**ASHLAND PLANNING DIVISION
PRE-APPLICATION CONFERENCE
COMMENT SHEET** March 4, 2020

SITE: 705 Helman Street
APPLICANT: BBT Architects
REQUEST: Site Review/CUP
Helman Elementary

Prototypical Section: 3-Lane Avenue

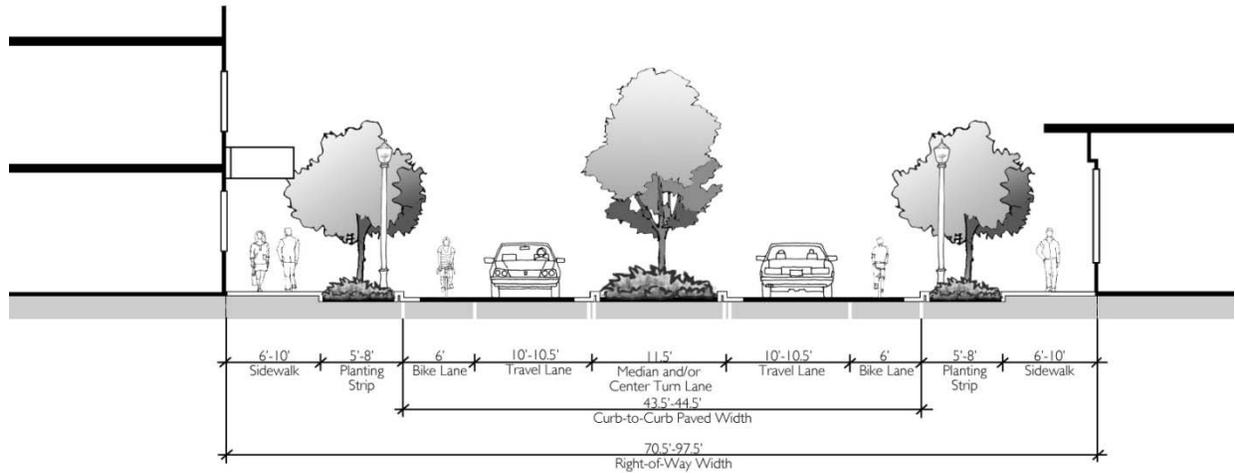
- **Street Standards & Controlled Access:**
 - ✓ **Helman Street** is considered to be an Avenue or Major Collector under the city’s Transportation System Plan or TSP. Street standards for avenues are discussed in AMC 18.4.6.040.G.2 and generally seek the cross-section below:

In terms of “controlled access” standards – which seek to limit the number and placement of access points - for collectors these standards generally seek a separation of 75 feet between driveways and placement of driveways at least 50 feet from the nearest intersection.

Prototypical Section: Residential Neighborhood Collector, Parallel Parking Both Sides

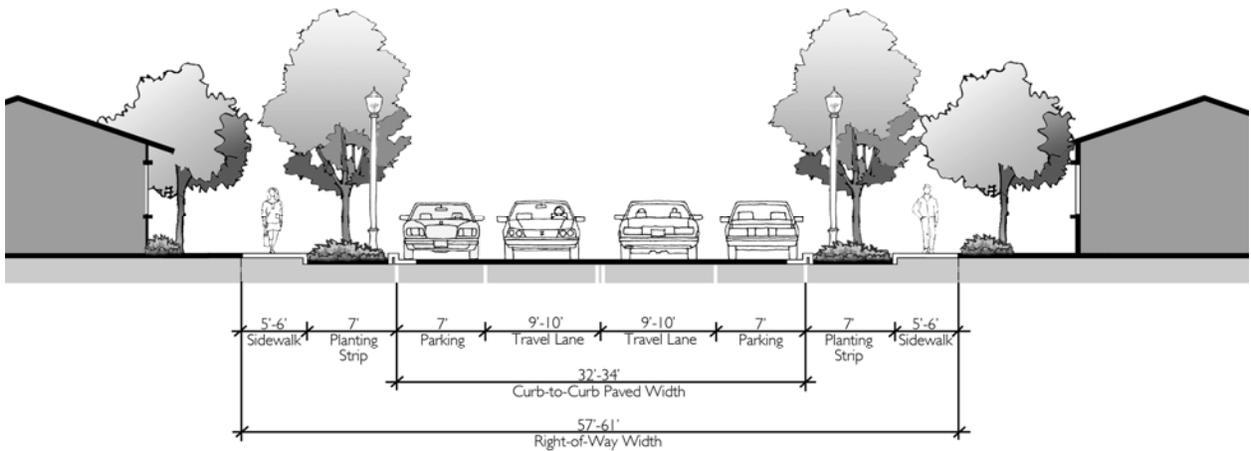
- ✓ **Laurel Street** is considered to be a Residential Neighborhood Collector under the city’s Transportation System Plan or TSP. Street standards for neighborhood collectors are discussed in AMC 18.4.6.040.G.3 and generally seek the cross-section below:

In terms of “controlled access” standards for collectors these standards generally seek a separation of 75 feet between driveways and placement of

driveways at least 50 feet from the nearest intersection.

Prototypical Section: Residential Neighborhood Street, Parallel Parking Both Sides

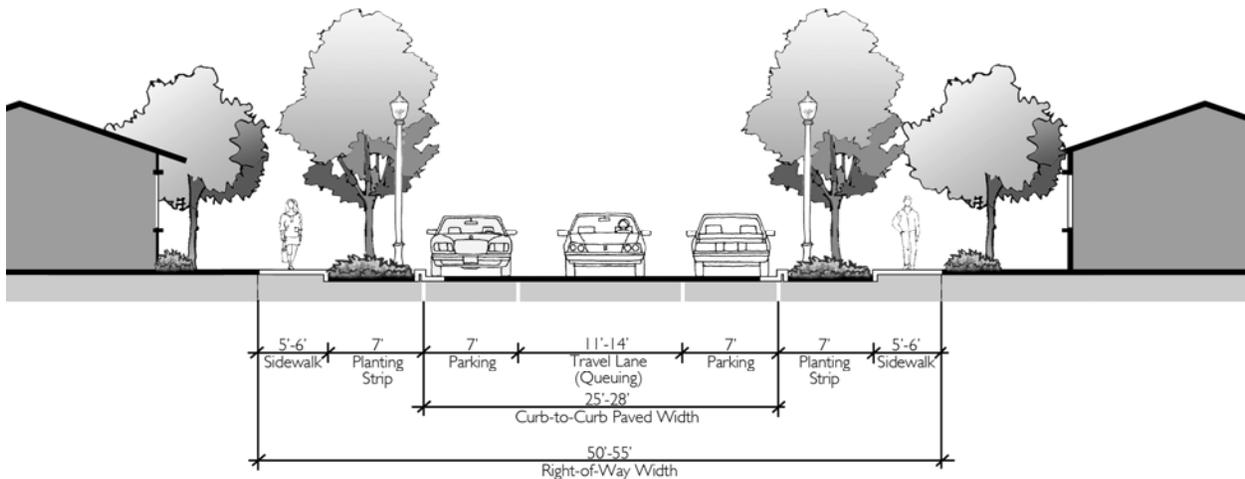
- ✓ **Randy Street** is considered to be a Residential Neighborhood Street under the city's Transportation System Plan or TSP. Street standards for neighborhood streets are discussed in AMC 18.4.6.040.G.4 and generally seek the cross-section below:

In terms of “controlled access”, standards for neighborhood streets generally seek a separation of 24 feet between driveways where there are two or fewer units per lot and a 50-foot separation where there are more than two units, and placement of driveways is to be at least at least 35 feet from the nearest intersection.
